IDAP REPORT

Property:	39 Augusta Street, Strathfield Lot 16 DP 14865 DA2021.212
Proposal:	Demolition of the existing structures, removal of trees, construction of a two-storey dwelling house with a basement level and in-ground swimming pool.
Applicant:	H.A Design Group
Owner:	Rise Partners Pty Ltd
Date of lodgement:	19 August 2021
Notification period:	30 August 2021 - 13 September 2021
Submissions received:	Nil
Assessment officer:	L Fanayan
Estimated cost of works:	\$1,379,663.00
Zoning:	R2-Low Density Residential - SLEP 2012
Heritage:	No
Flood affected:	Yes
RECOMMENDATION OF OFFICER:	APPROVAL

Figure 14: Void spaces above to the stairwell, foyer and dining room.

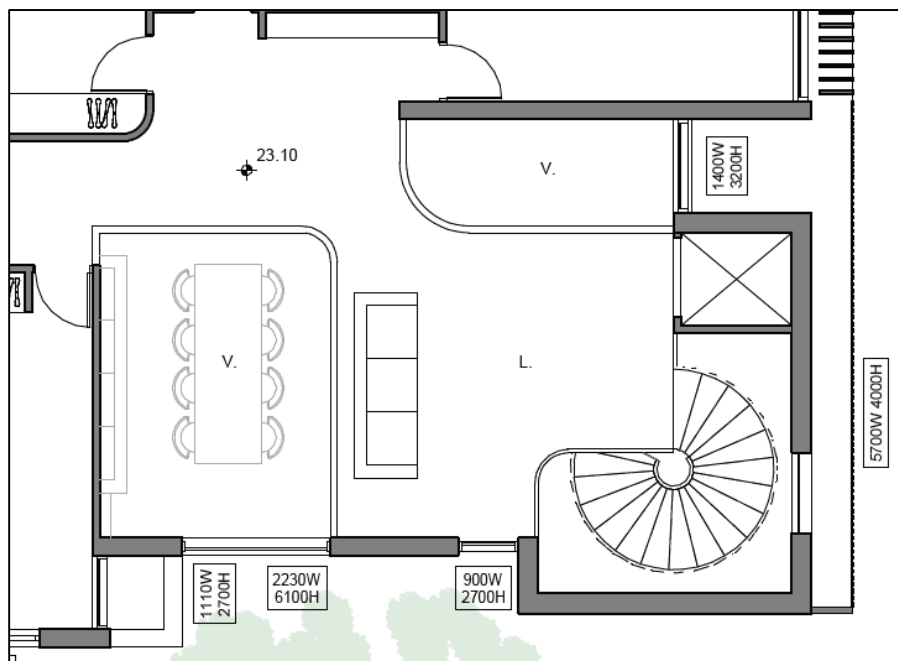
The void spaces included in the first floor of the design are considered reasonable and acceptable. These voids relate to the stairwell, foyer and the dining room (refer to Figure 14). The void above the formal dining room provides additional solar access and amenity for the dining room and first floor living room and circulation space. It is noted that the external walls of the void spaces above the dining room and foyer are recessed and articulated in a manner that minimises the bulk and presentation of these voids.

To ensure that the void space above the formal dining room remains a void an ongoing condition will be included in the consent.

Figure 15: Pool height above ground

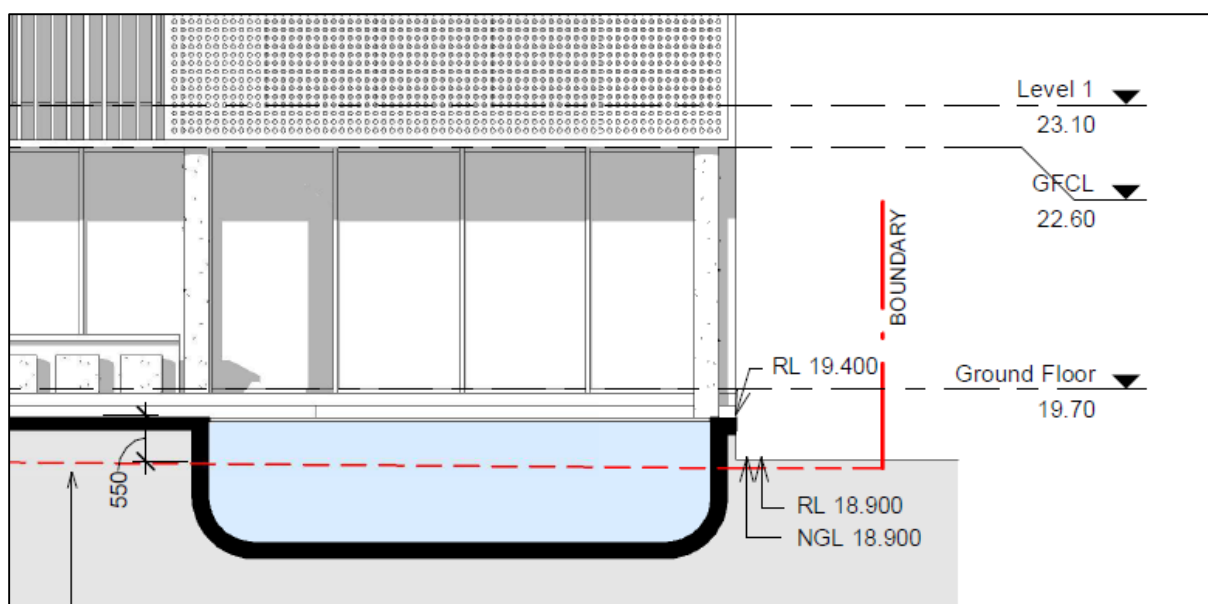
The pool area has a slight elevation of 0.5m above natural ground and steps down to 0.3m (towards the eastern boundary). The inclusion of screen planting in combination with the 1.75m setback from the western boundary will assist in minimising potential privacy impacts associated with the pool area.

Figure 16: Measurements of the proposed basement ramp.

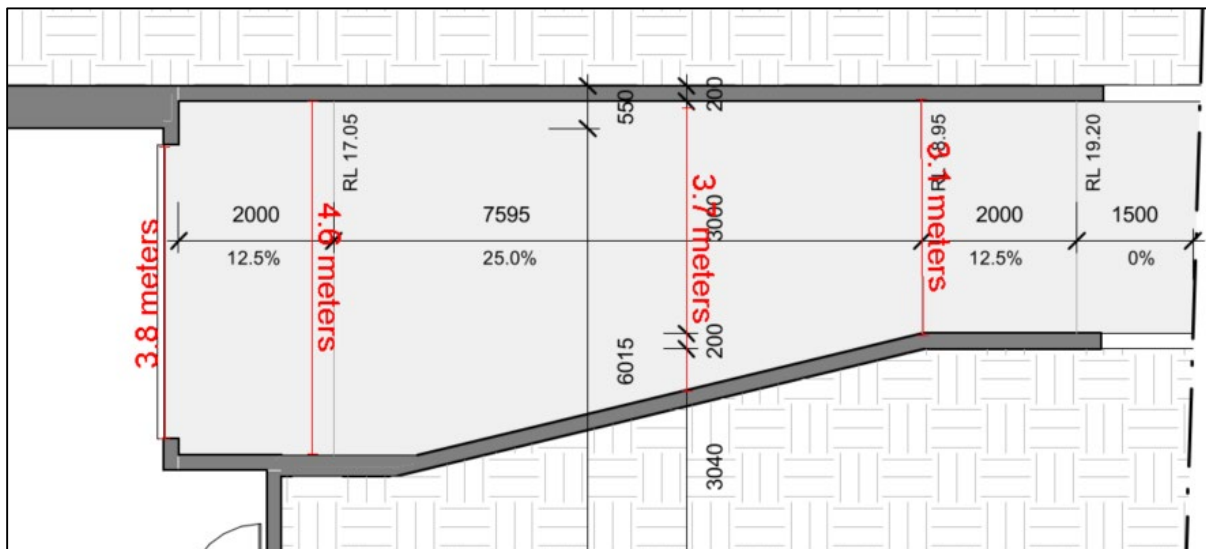
The proposed basement ramp width features a variable width of 3.1 to 4.6m. This ramp fails to comply with Clause 8.2.3.6 of SCDCP 2005 which requires a maximum ramp width of 3.5m. In order to comply with this control, a design change condition will be imposed to reduce the width of the ramp. The reduced width ensures a minimal amount of ground disturbance is necessitated for creating the ramp and ensures a more discrete presentation of the basement access can be achieved.
